2010 Regulatory Correspondence between NMED HWB and the Air Force regarding the Kirtland AFB BFF Spill

**April 2, 2010 Correspondence from NMED HWB
to Colonel Michael S. Duvall, Base Commander, 377 ABW/CC
Re: SWMUs ST-106 and SS-111, BFF Spill, Kirtland, AFB**

**RE: SOLID WASTE MANAGEMENT UNITS ST-106 AND SS-111, BULK
FUELS FACILITY SPILL
KIRTLAND AIR FORCE BASE
EPA ID# NMD9570024423, HWB-KAFB-10-004**

**RE: BULK FUELS FACILITY SPILL, SWMUS ST-106 AND SS-111
DIRECTIVE FOR CONDUCTING INTERIM MEASURES AND NOTICE OF
DISAPPROVAL
INTERIM MEASURES WORK PLAN, JUNE 2010;
VADOSE ZONE WORK PLAN, JUNE 2010;
GROUNDWATER INVESTIGATION WORK PLAN, JUNE 2010
KIRTLAND AIR FORCE BASE, EPA ID# NM9570024423
HWB-KAFB-10-015, HWB-KAFB-10-016, HWB-KAFB-10-019**

Figure 1. Soil Boring and Soil-Vapor Monitoring Well Locations

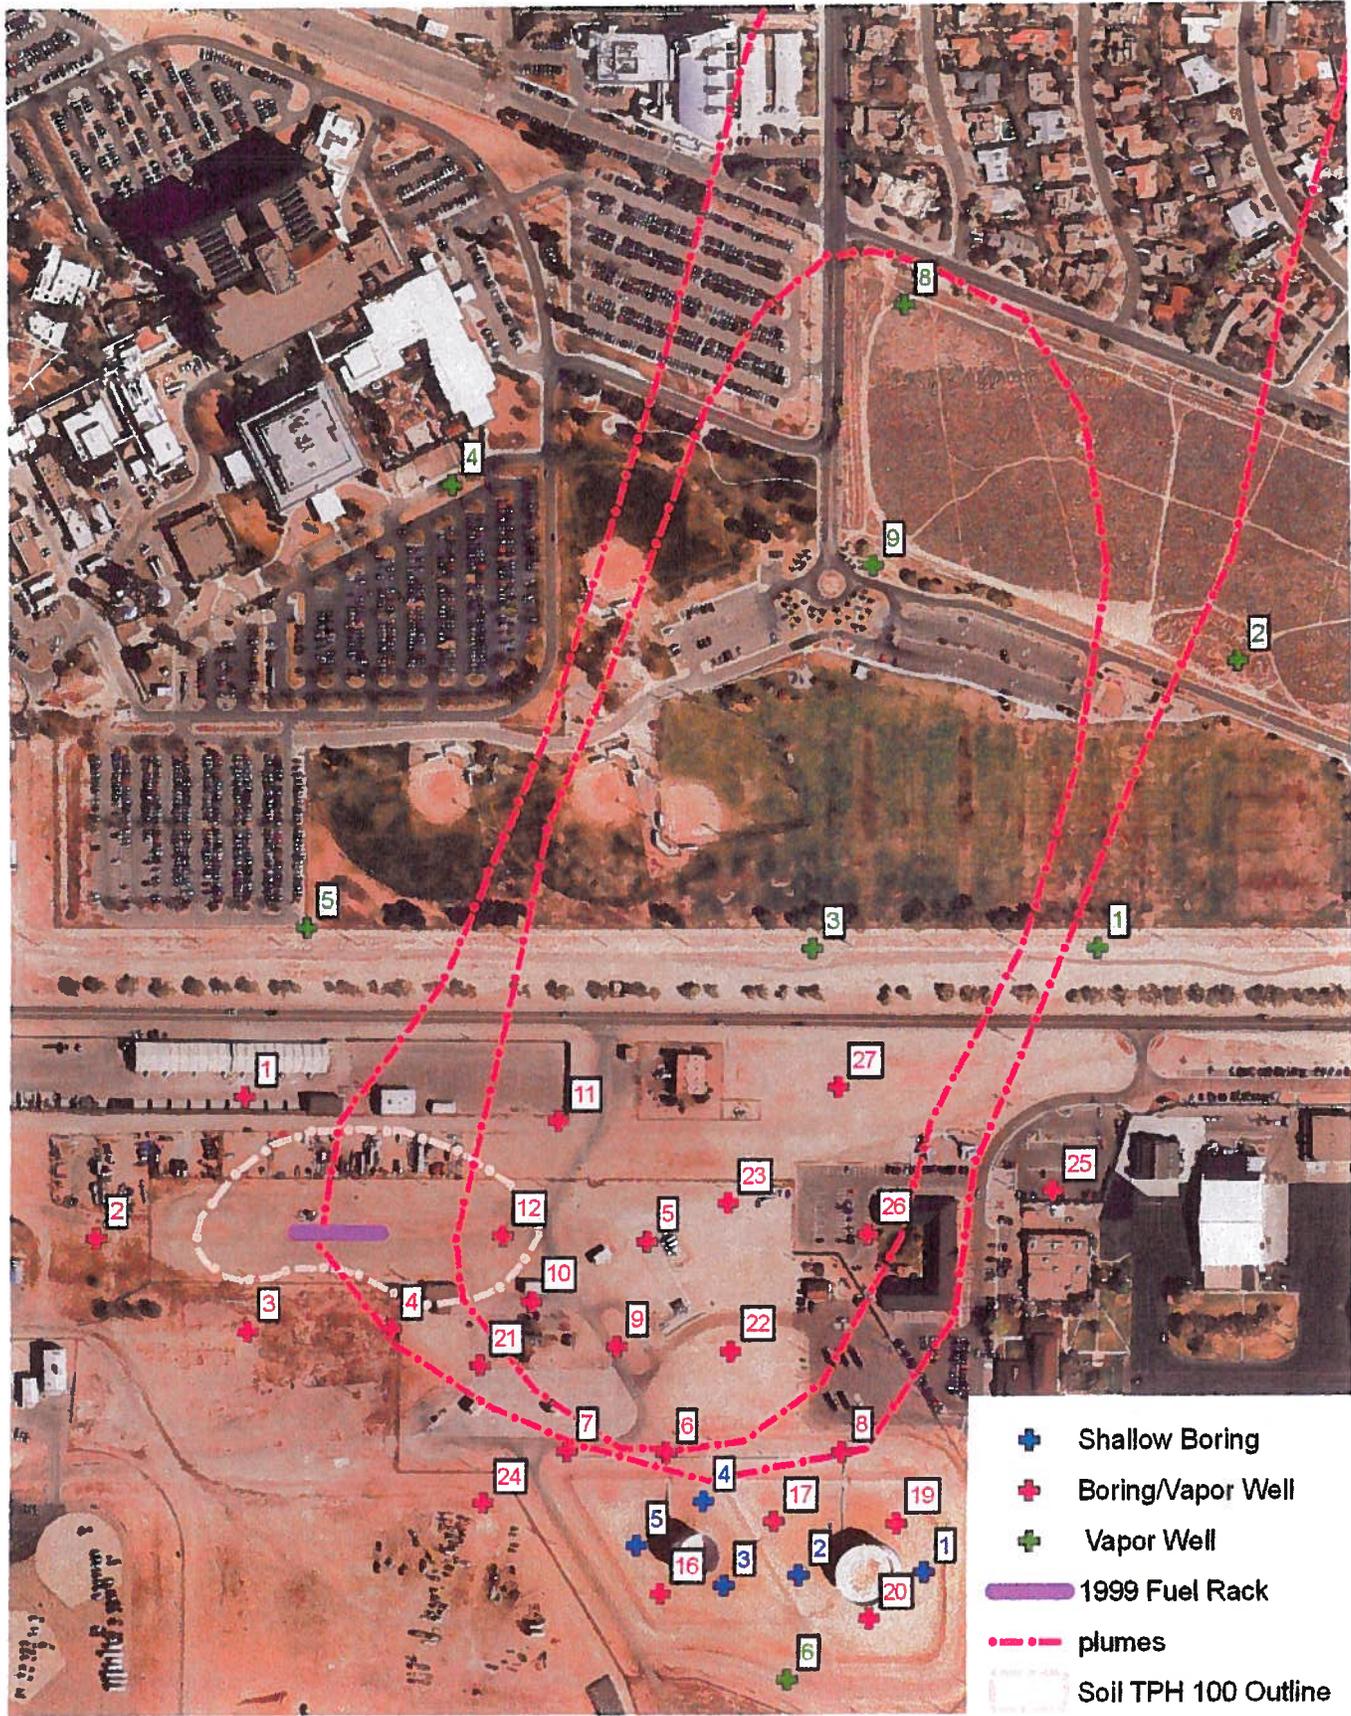
The Permittee shall complete the soil borings/soil-vapor wells at locations #16, 17, 19 and 20; and the soil vapor well at location #6 that are listed in Tables 1 and 2 of this letter, respectively, and shown on Figure 1 enclosed with this letter. The Permittee shall also complete shallow soil borings to a depth of at least 20 feet at locations #1 through 5, which are listed in Table 3 of this letter and shown also on Figure 1. Soil samples from the shallow borings shall be collected at depths of 0, 5, 10, 15, and 20 feet and shall be analyzed for TPH, VOCs, SVOCs, and lead.

The Permittee shall complete the deep soil borings/soil-vapor wells at locations #4, 6, 7, 8, and 24 that are listed in Table 1 of this letter and shown on Figure 1. The Permittee shall also complete shallow borings along the entire length of the pipeline between the tank farm and the Fuel Offloading Rack, regardless of whether the pipeline runs underground or on the surface. The borings shall be spaced at intervals not to exceed 25 feet and are to be located on both sides of the pipeline. Soil samples from the shallow borings shall be collected at depths of 0, 5, 10, 15, and 20 feet. The soil samples from deep and shallow borings shall be analyzed for TPH, VOCs, SVOCs, and lead. Depending on the results, NMED may require further investigation of this area, including more and deeper borings.

The Permittee did, however, propose an additional 3 deep soil sampling/vapor wells at locations further to the east. NMED agrees that these latter locations are necessary to properly characterize this area. Thus, to improve the understanding of the amount of fuel contamination in the vadose zone that must be remediated, the Permittee shall complete the soil borings/soil-vapor wells at locations #5, 9, 10, 21, 22, 23, 25, 26, and 27 listed in Table 1 and shown on Figure 1.

5. Far field area of Soil-Vapor plume – In its letter of April 2, 2010, NMED directed the Permittee to install six soil-vapor wells at locations north of the Fuel Offloading Rack and fuel percolation area to investigate the concentrations of hazardous constituents in soil gas that overlies groundwater in these areas. The Permittee shall complete the soil-vapor wells at locations #1, 2, 4, 3, 5, 6, 8, and 9; and the soil boring/soil-vapor well at location #24, that are listed in Tables 2 and 1, respectively, and shown on Figure 1.

The coordinates in Tables 1-3 are State Plane Coordinates in feet, NAD83. All boring/soil vapor well locations are also shown on Figure 1 enclosed with this letter.

Figure 2. Groundwater Monitoring Well Locations

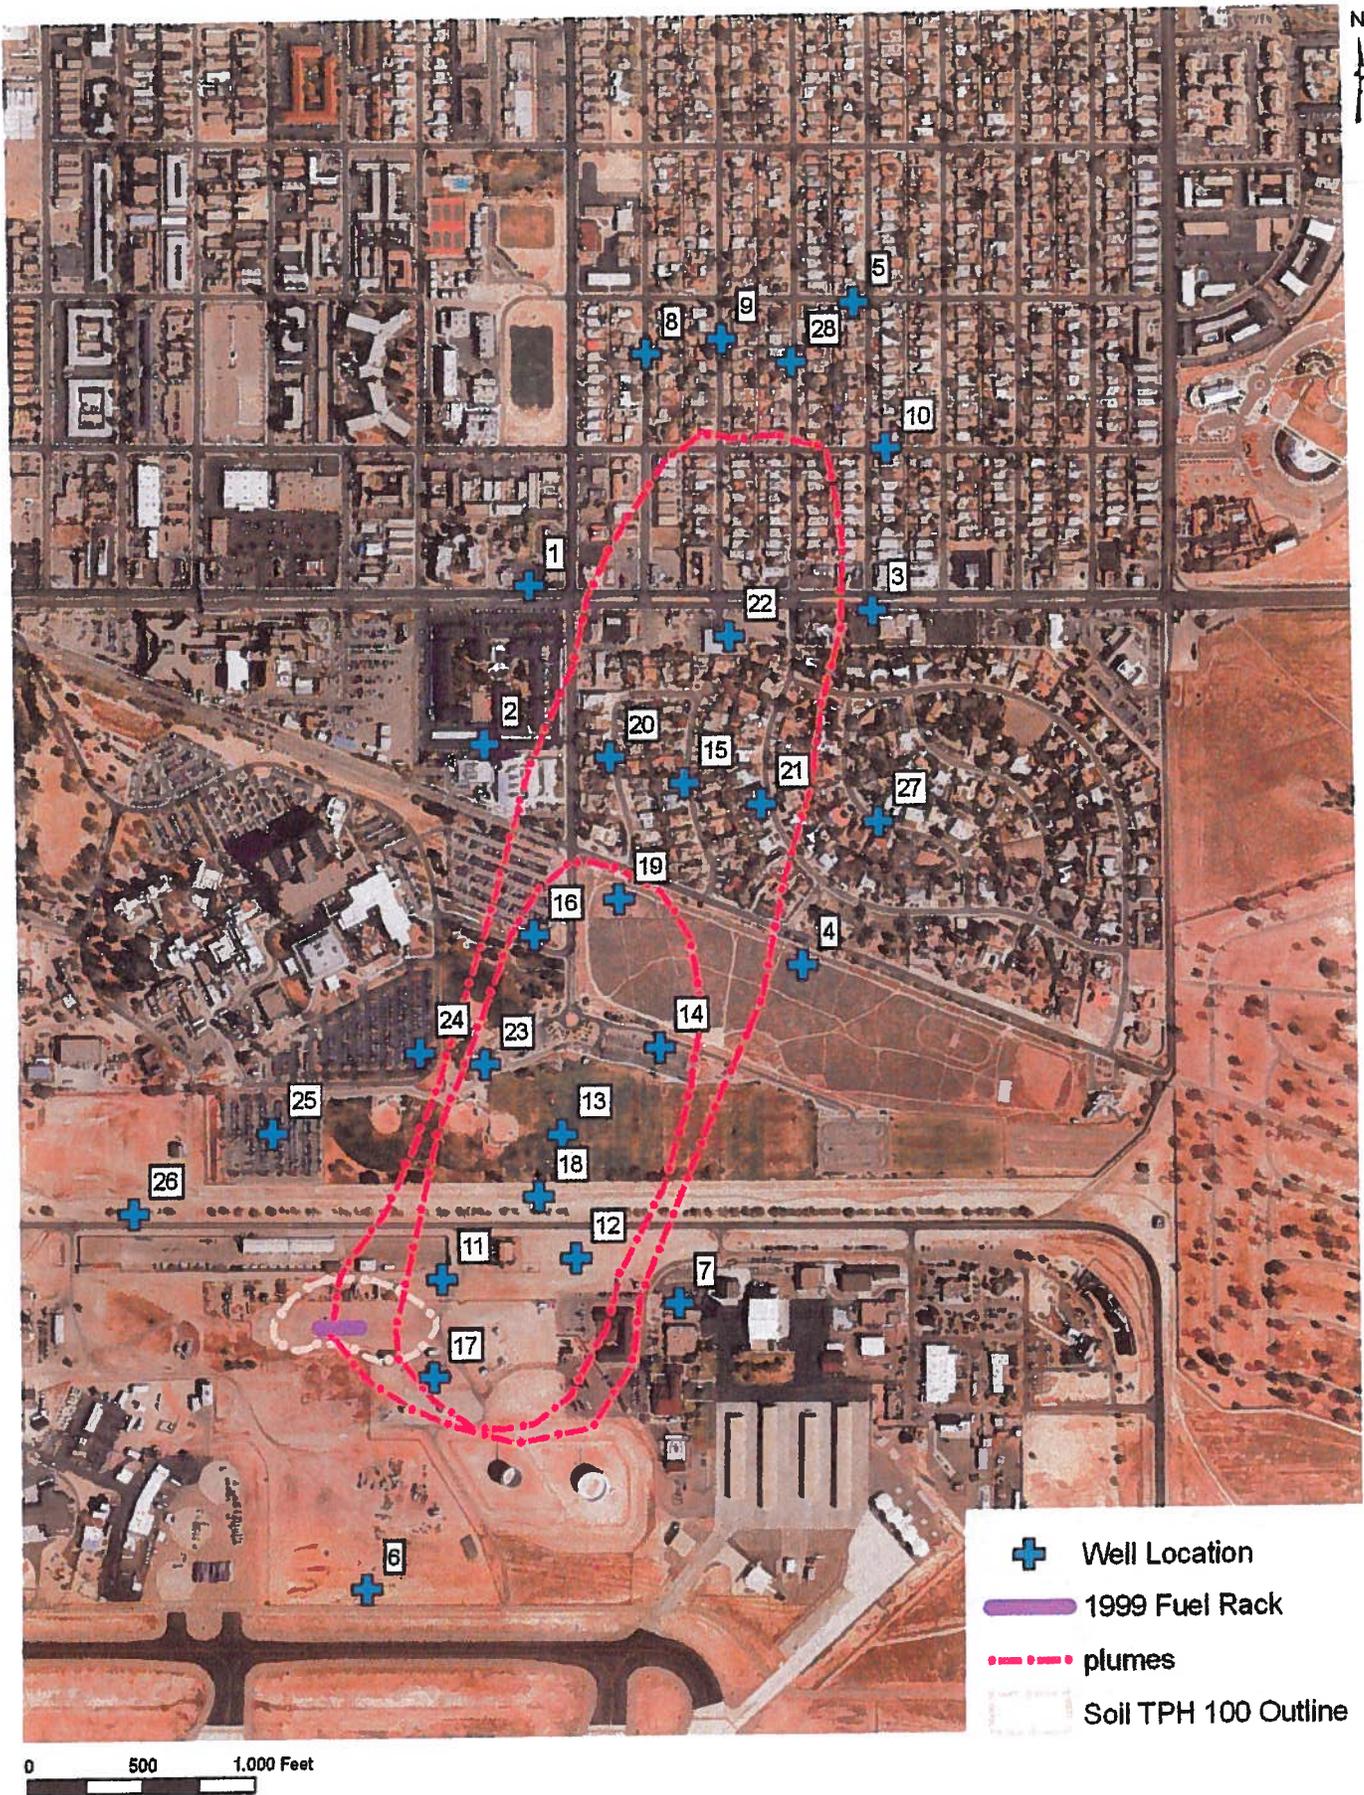
1. Background Water Quality - Only two upgradient wells have been installed that potentially may yield groundwater samples that are free from contamination. Both of these wells were only recently completed; none is screened appreciably below the water table to provide vertical characterization of water quality, geology, and hydrologic conditions. The Permittee must complete the background cluster/nested wells at location #6 listed in Table 4 of this letter and shown on Figure 2 (enclosed).

To achieve the objective of providing initial plume-core characterization, the Permittee shall install the groundwater monitoring wells at locations #11, 12, 13, 14, 15, 16, 17, 18, 19, 20, 21, 22, and 23 listed in Table 4 and shown on Figure 2.

To adequately provide initial plume-edge characterization, the Permittee shall install the groundwater monitoring wells at locations #1, 2, 3, 4, 5, 7, 8, 9, 10, 24, 25, 26, 27, and 28 that are listed in Table 4 and shown on Figure 2.

Coordinates in Table 4 are State Plane Coordinates in feet, NAD83. All of the locations listed in Table 4 are also shown on Figure 2 enclosed with this letter.

Figure 3 Existing Soil Boring, Soil-Vapor Monitoring Well and Cross-Section Locations

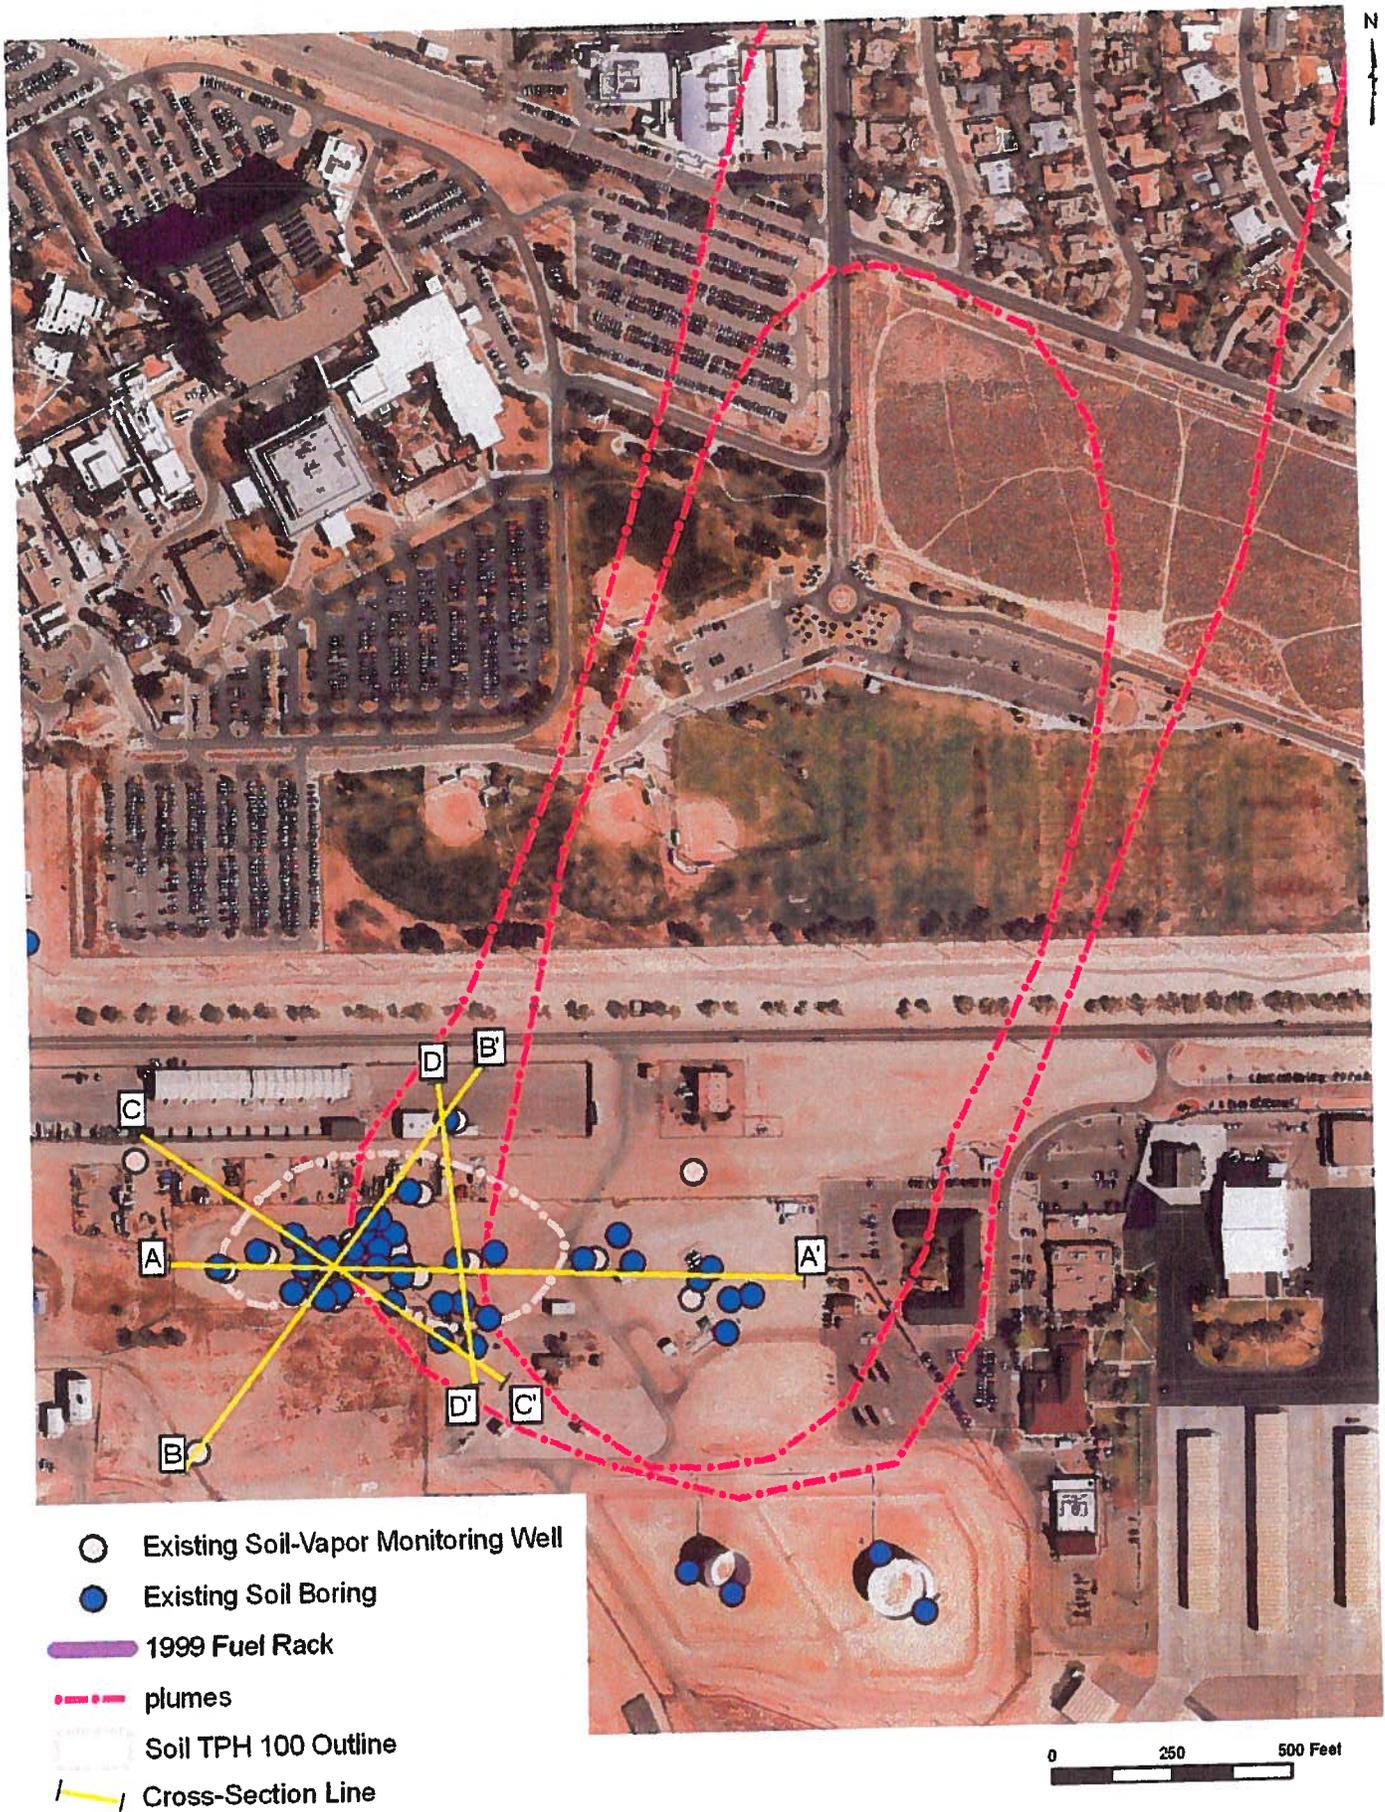
- v. Cross-sections showing the geology of the site drawn to a horizontal scale of 1 inch equals 50 feet, a vertical scale of 1 inch = 50 feet, and along the orientations A-A', B-B', C-C', and D-D' as shown on Figure 3 enclosed with this letter.

- vii. Cross-sections showing concentrations of major hazardous constituents in soil, drawn to a horizontal scale of 1 inch equals 50 feet, a vertical scale of 1 inch = 50 feet, and along the orientations A-A', B-B', C-C', and D-D' as shown on Figure 3 enclosed with this letter.

- viii. Cross-sections showing concentrations of major hazardous constituents in soil vapor, drawn to a horizontal scale of 1 inch equals 50 feet, a vertical scale of 1 inch = 50 feet, and along the orientations A-A', B-B', C-C', and D-D' as shown on Figure 3 enclosed with this letter.

Figure 4. Existing Well and Cross-Section Locations

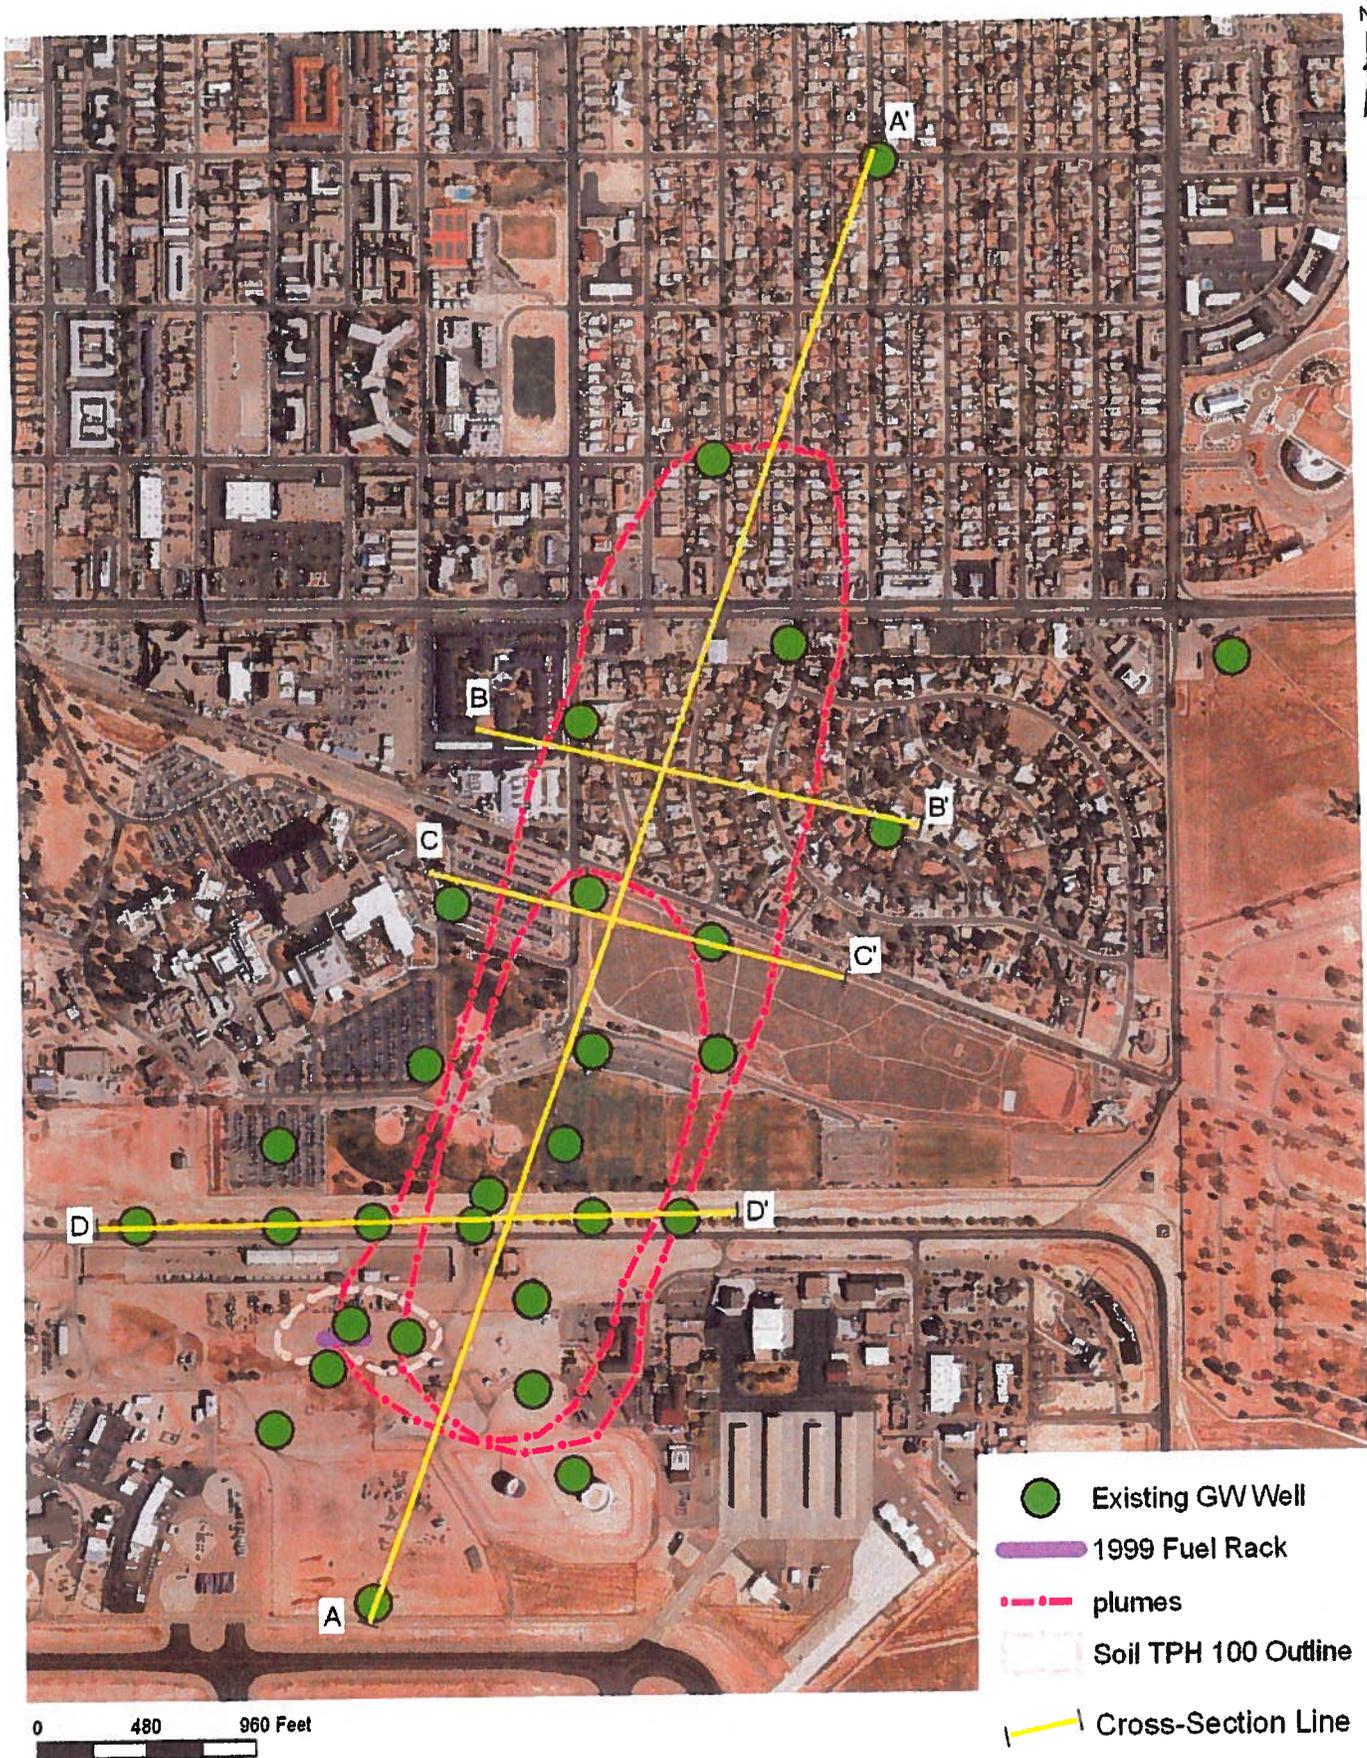
- vi. Cross-sections showing the geology of the site drawn to a horizontal scale of 1 inch equals 300 feet, a vertical scale of 1 inch = 50 feet, and along the orientations A-A', B-B', C-C', and D-D' as shown on Figure 4 enclosed with this letter.

- ix. Cross-sections showing concentrations of major hazardous constituents in groundwater, drawn to a horizontal scale of 1 inch equals 300 feet, a vertical scale of 1 inch = 50 feet, and along the orientations A-A', B-B', C-C', and D-D' as shown on Figure 4 enclosed with this letter.
